Planning Commission
Regular Meeting Notice & Agenda

NORTH KINGSTOWN PLANNING COMMISSION STAFF REPORT

Agenda Topic: 1) Development Plan (Modification) for The Back 40 located at 20 South County Trail, AP 102 Lot 7 & 2) Recommendation to the zoning board of review for parking and signage.

SHEET
C-2
2 OF 3

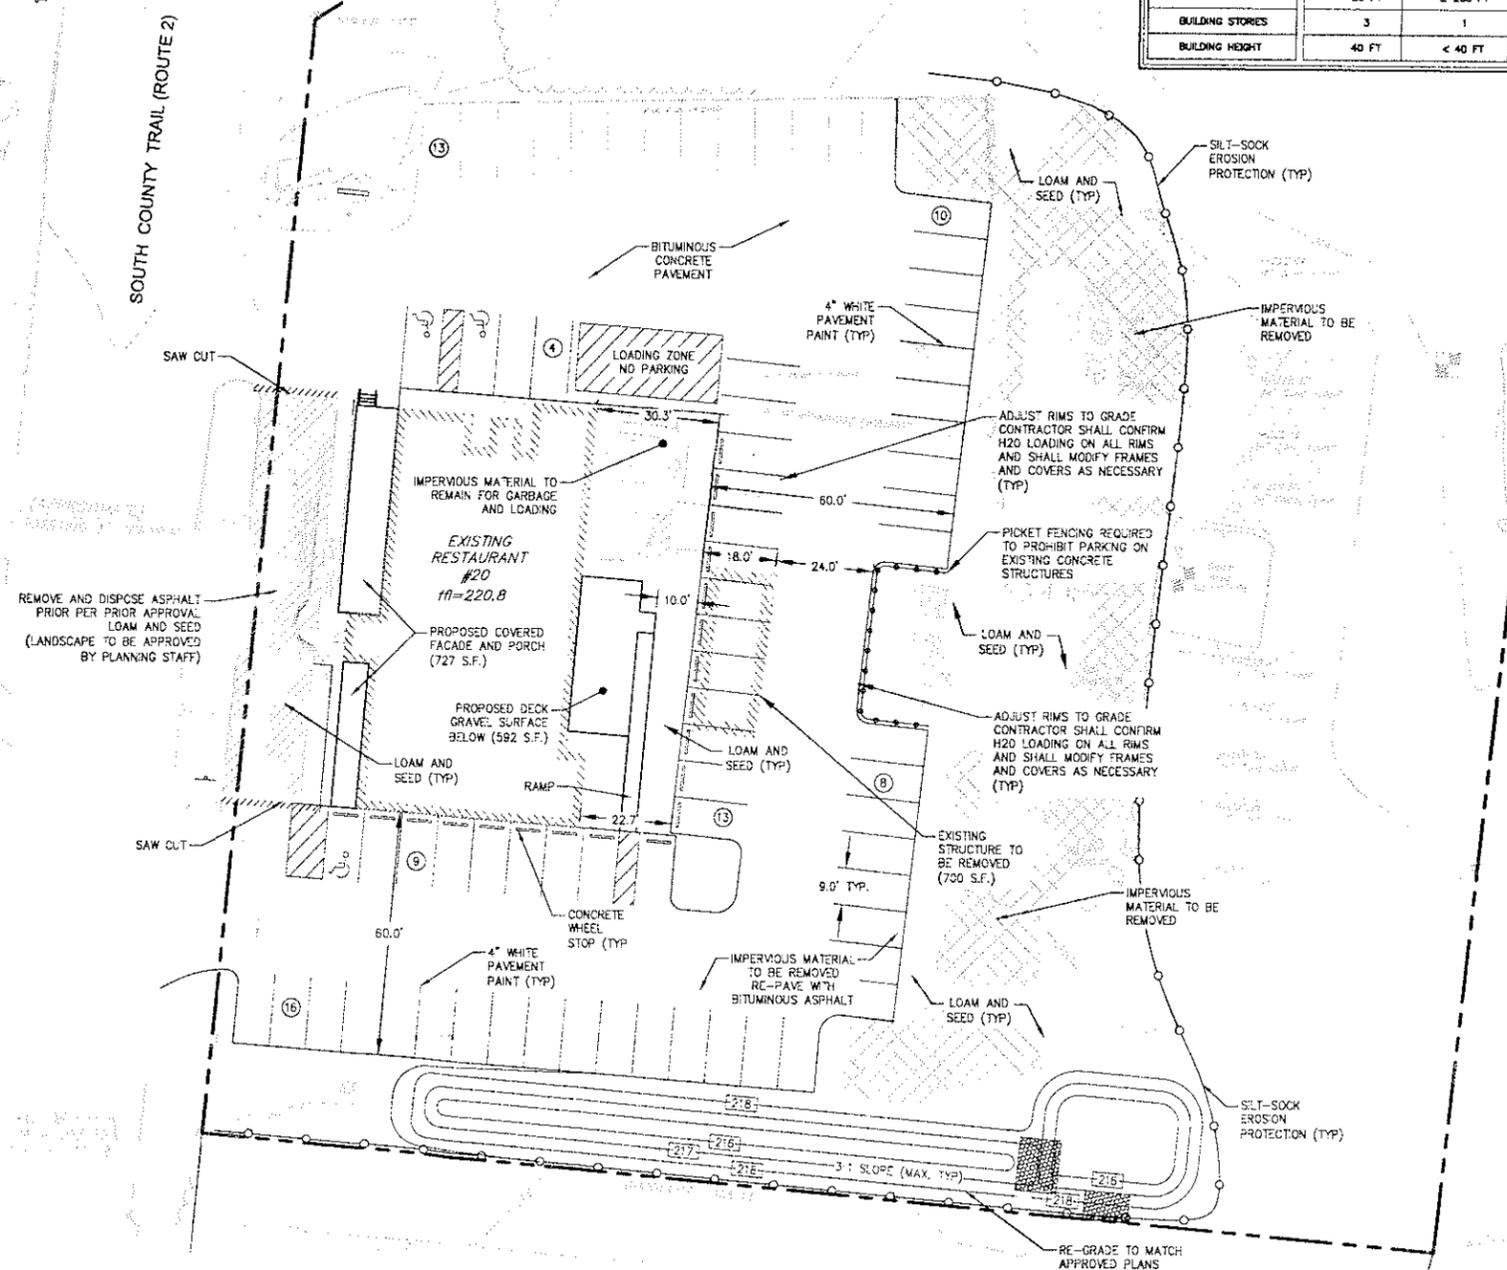
I reviewed the 10/25/16 letter from Garofalo and the site plans for the above proposed redevelopment. I checked the site plans against the RIDOT's Rt. 102/Rt. 2 roundabout plans as well. I have no issues with the proposal. I would however, like to see that the plans show the parking lot graded to drain to the water quality swale and basin on the south side of the property.

EXTERIOR ELEVATIONS

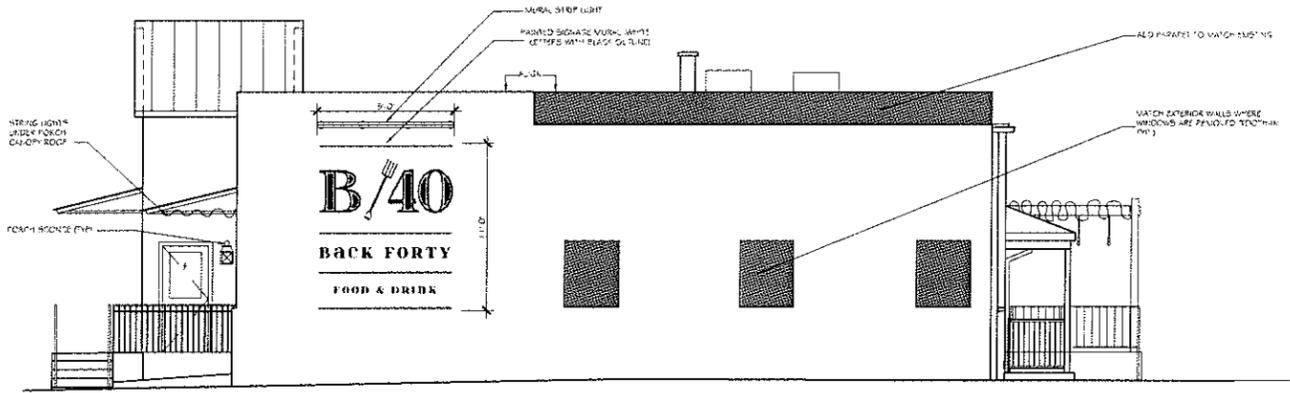
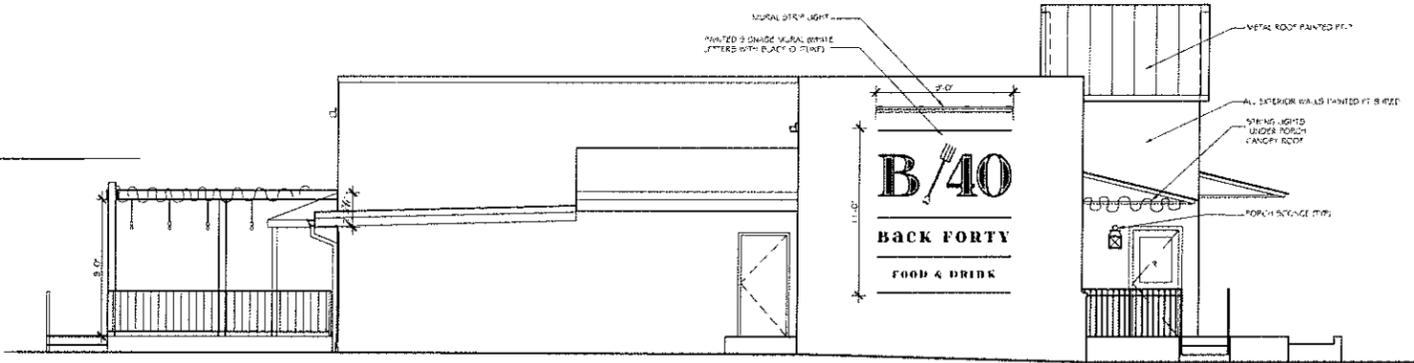
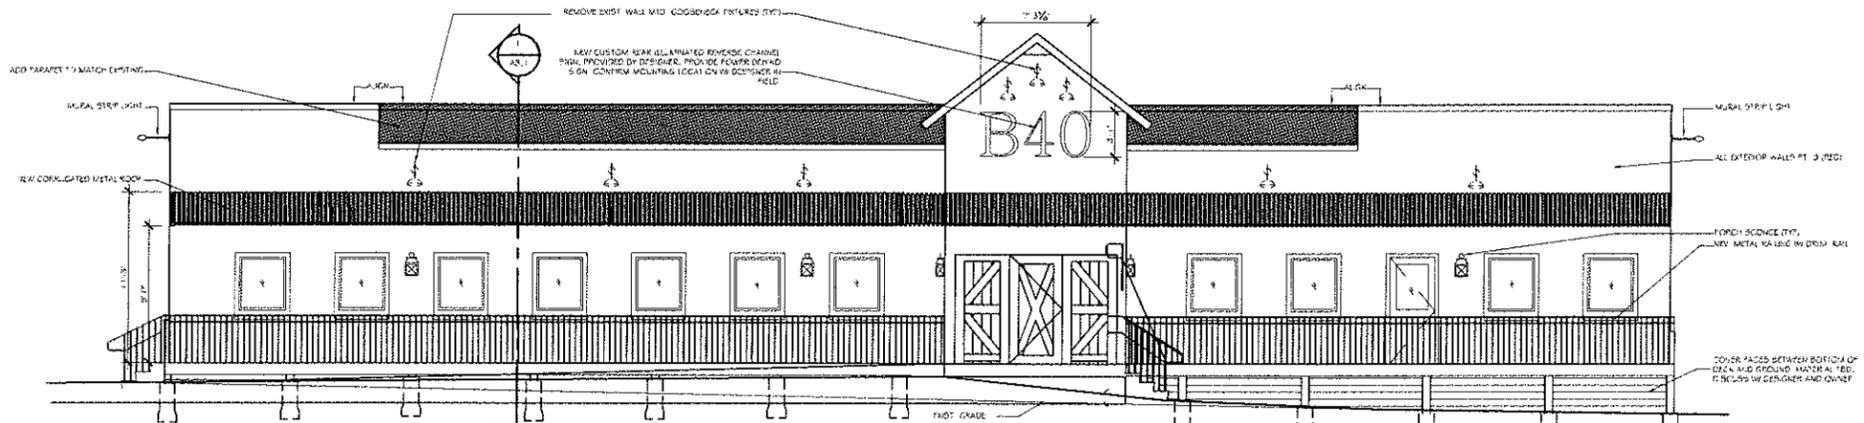
The application is also proposing two signs, 99 sq. ft. each, one to be located on the southern side elevation and one on the northern side elevation. These signs have been indicated as murals on the submitted plans and indicate that they will be “painted signage mural (white letters with black outline)”. There has been some degree of discussion with this with the applicant’s engineer. The zoning ordinance indicates that murals require a special use permit. The ordinance does not include a definition of a mural, but has been interpreted as the painting of graphics on walls. This proposal consists primarily of logos and advertising as it indicates the B40 logo with an image of a pitchfork and Back Forty written out under it with Food and Drink on the third line. The definition of a sign as per our zoning ordinance indicates that it *“means any device, whether freestanding or attached to a building or structure, or that is erected, painted, represented or reproduced upon or in (to the extent provided in this chapter) any building or structure, which displays, reproduces or includes any letter, work, name, number, model, insignia, design, device or representation used for one or more of the following:*

On this basis, the planning staff is of the opinion that these would constitute signs. There is an allowance for signage on the sides of buildings under Section 249 (1) (b) which allows an additional 10 sq. ft. of signage when the building directly or indirectly abuts a parking lot. Anything over the allowable 10 sq. ft. would require relief (dimensional variances) from the zoning board of review. These signs would therefore each require 89 sq. ft. of relief.

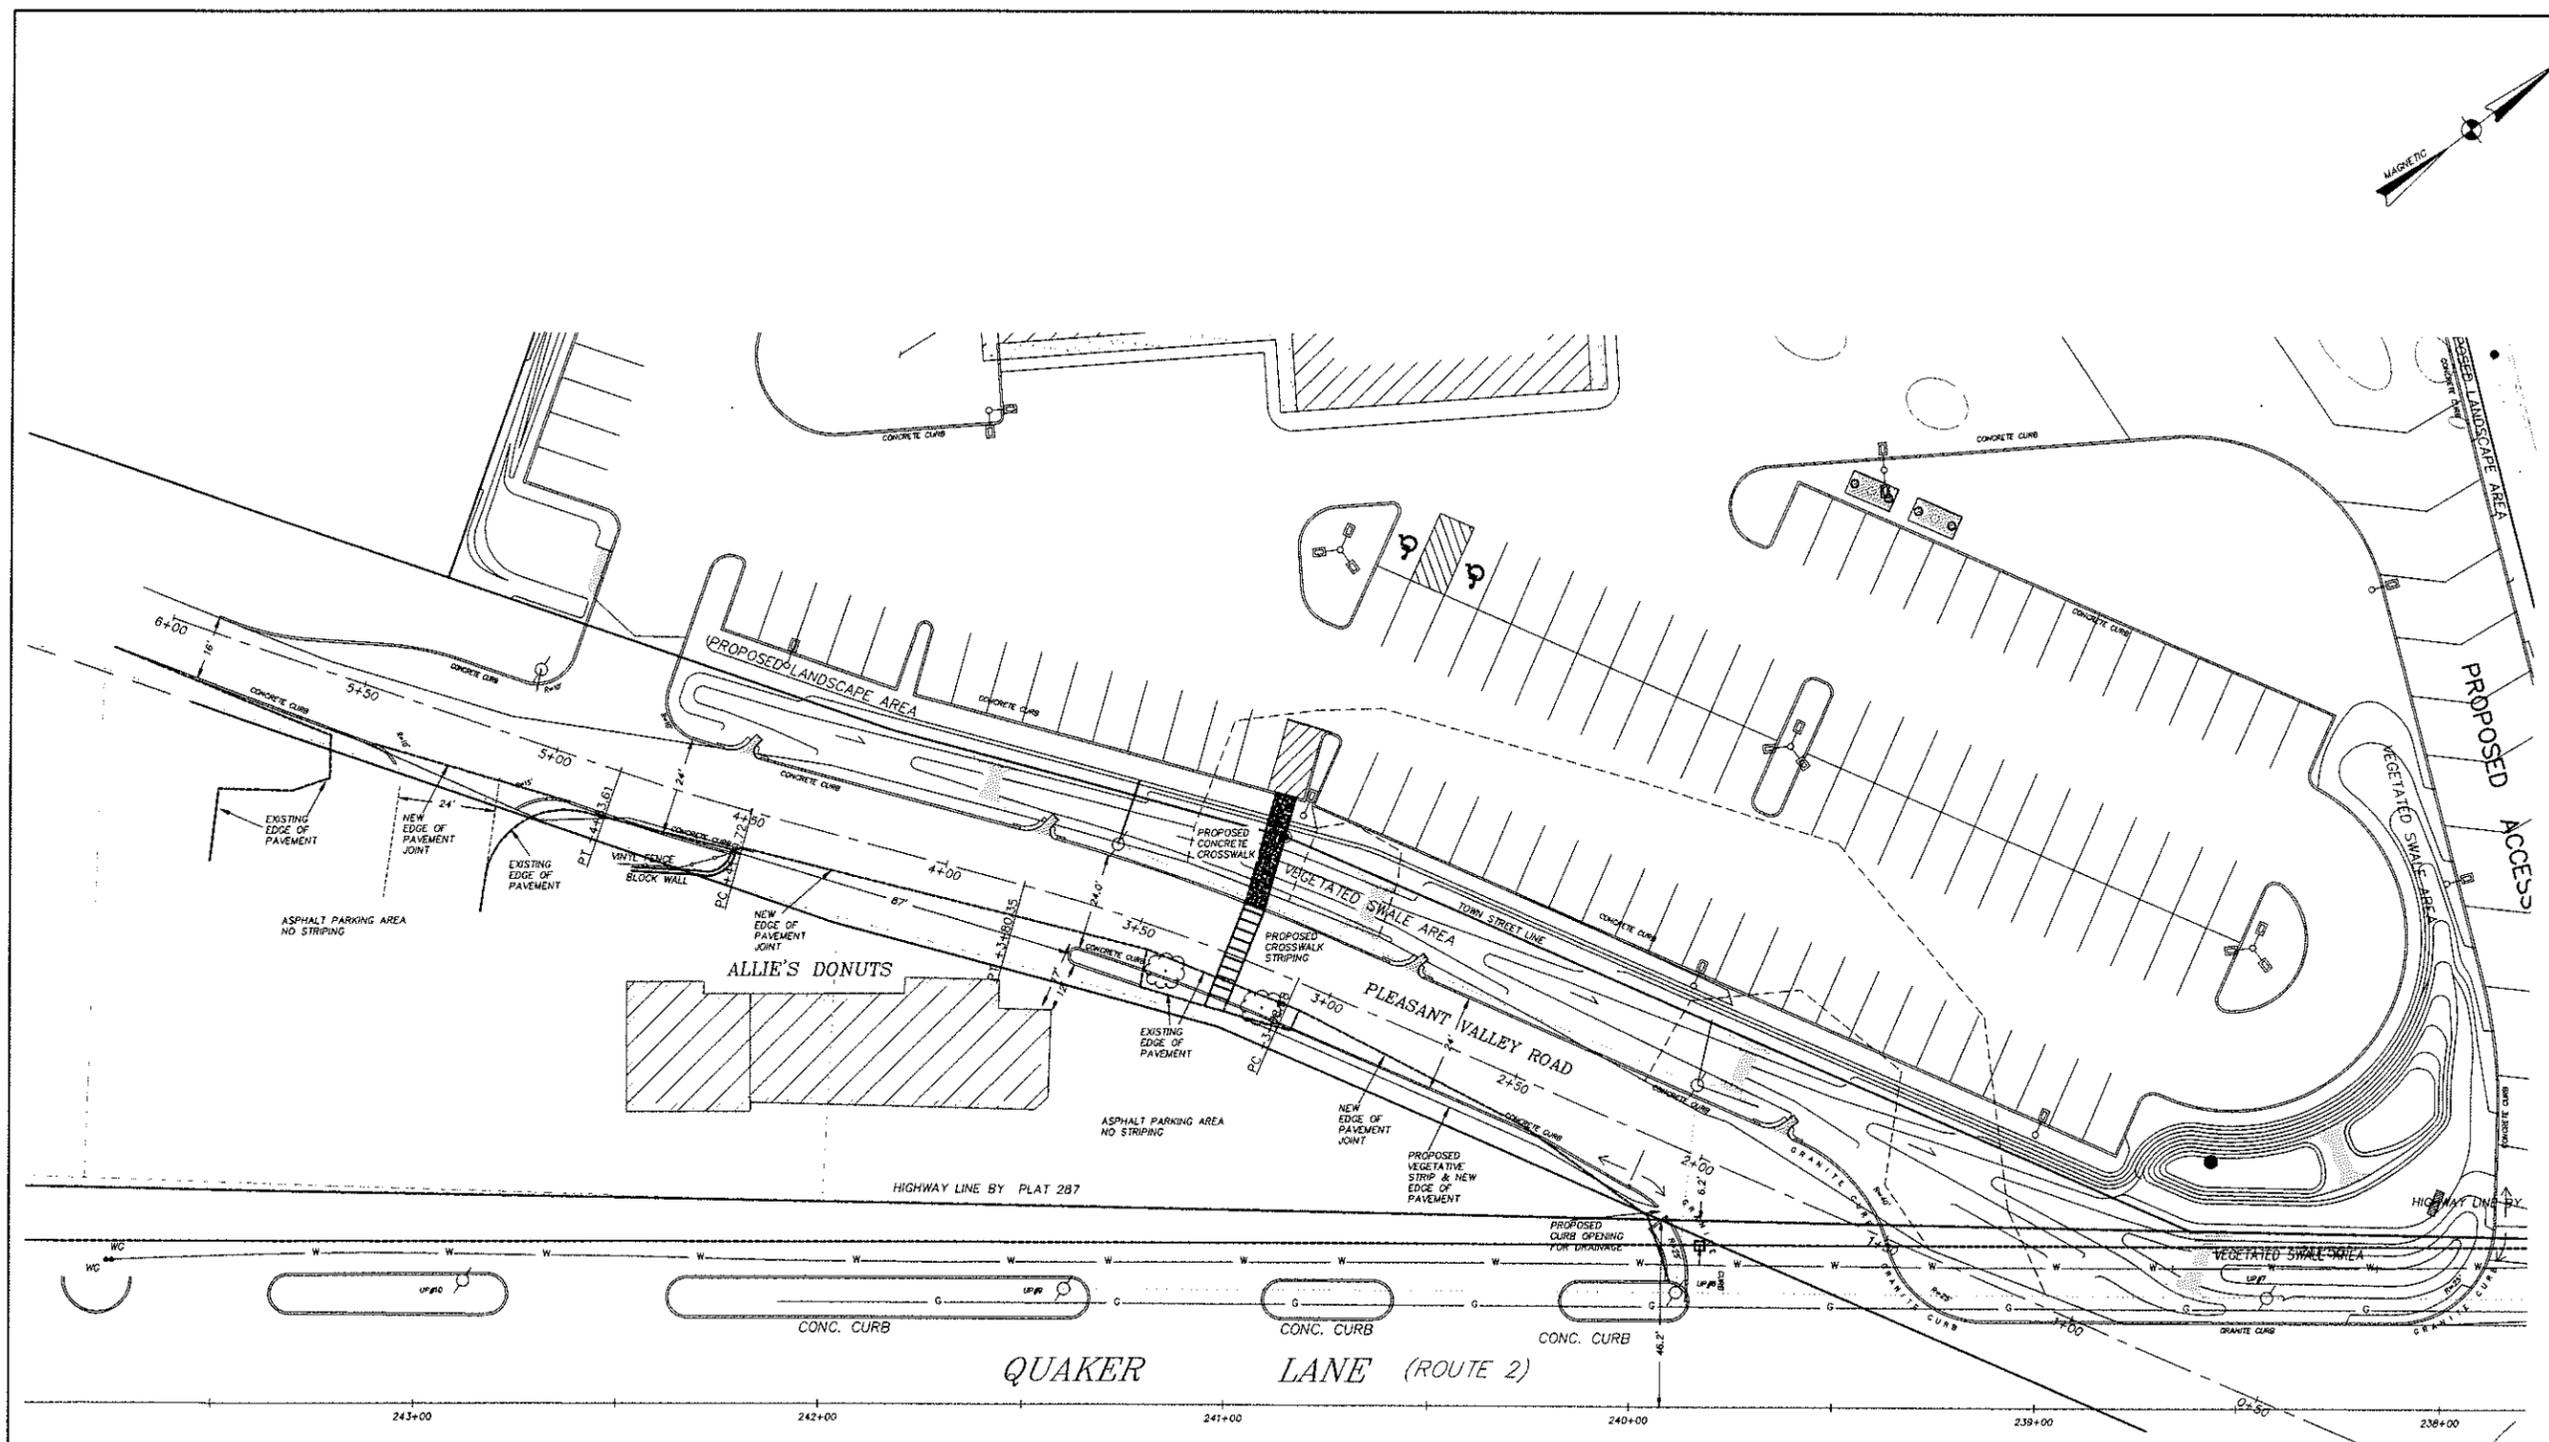
Engineering has reviewed revised plans for concrete curbing on the south side of Pleasant Valley Road, adjacent to Allies Donuts.

Mr. Dresher of Allies asked for the opening at the southern end to be kept open. I agreed, but concluded with Tarbox's engineer that the opening was wider than it needed to be. The paved access for the southern paved area, which was proposed to be curbed, was revised to allow an opening, but a defined, standard 24 foot opening.

It is our understanding that deliveries to Allies use a tractor trailer that backs up nearly parallel to the building, facing north. I measured the area behind his building with Mr. Dresher. The opening in the revised plan has been widened to allow a delivery truck to get off the traveled roadway while unloading. Mr. Dresher wanted it left open more, but conceded with what we measured off that there would be room for a tractor trailer to pull in.

Between Quaker Lane and the back of the building, the curbing adheres to the original plan which is to be continuous curbing. Mr. Dresher wanted an opening closer to Quaker Lane, but in meeting with the police, they were clear that it would be safer closed. In earlier discussions with Mr. Tarbox, he originally wanted all the curbing to be kept, per plan. His reasoning was that his own access on to Pleasant Valley had been very strictly limited to restrict traffic. In addition, after input from the Fire Marshall, the defined road within the ROW was been narrowed from 26 feet to 24 feet wide, to discourage parking on the sides of the road.

It is the opinion of this office, that these modifications address the safety concerns on Pleasant Valley Road, while accommodating the operational needs of all the businesses there.
